Sample Company

Main Electrical Room

Switch #1

Problem #	3
Repair Priority	Urgent
Hot Spot	79.4°C
Ref. Temp	36.0°C
Delta T	43.4
Time	Any Time
Date	Any Day

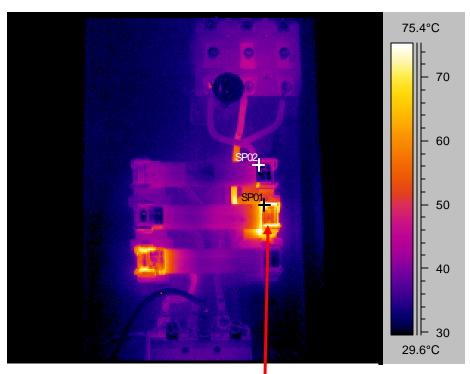
The lower left and center right fuse clips are hot. Loose wire connections or poor fuse clip tension is suspected.

Remove all the fuses, clean the fuse contact areas and fuse clip contact areas, reassemble. Check fuse clips for proper tension. Replace if necessary. Clean the wire to lug connection. Check all the lugs for proper torque.
